INITIAL FIRE SAFETY INSPECTION REPORT

Factory Name: Joy Auto Garments Ltd.

RSC ID: 24457

Date: 19th July, 2022

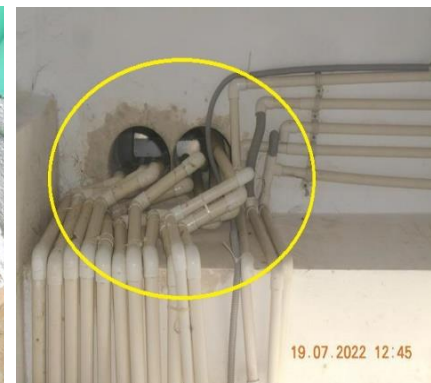
SI No.	Category	Findings	Required Action	Remediation Time Frame
F-1	Fire Rated Construction	Building-01 The exit stairs are not separated from [work areas, other spaces] on each floor by fire-rated construction.	Provide minimum 2-hr fire rated construction for buildings 4 storied or more and 1-hr for upto 3 storied. Seal all unprotected openings to separate the exit stairs from work areas and other spaces on all floor levels by 90 minutes for 2 hr construction and 60 minutes for 1-hr construction. Ensure that the fire rated doors are self-closing and positive latching and that they are provided with fire exit (panic) hardware where serving production floors and provide vestibules to avoid direct discharge from storage to exit stair enclosure. If fire rated doors are required to be held open for functional reasons, provide automatic closing devices tied to the fire alarm system. Once fire doors are installed, every door in a stair enclosure serving more than 5 stories shall be provided with re-entry unless it meets The RSC Technical Guidelines (Standard) 6.8.3.1	Within 3 months
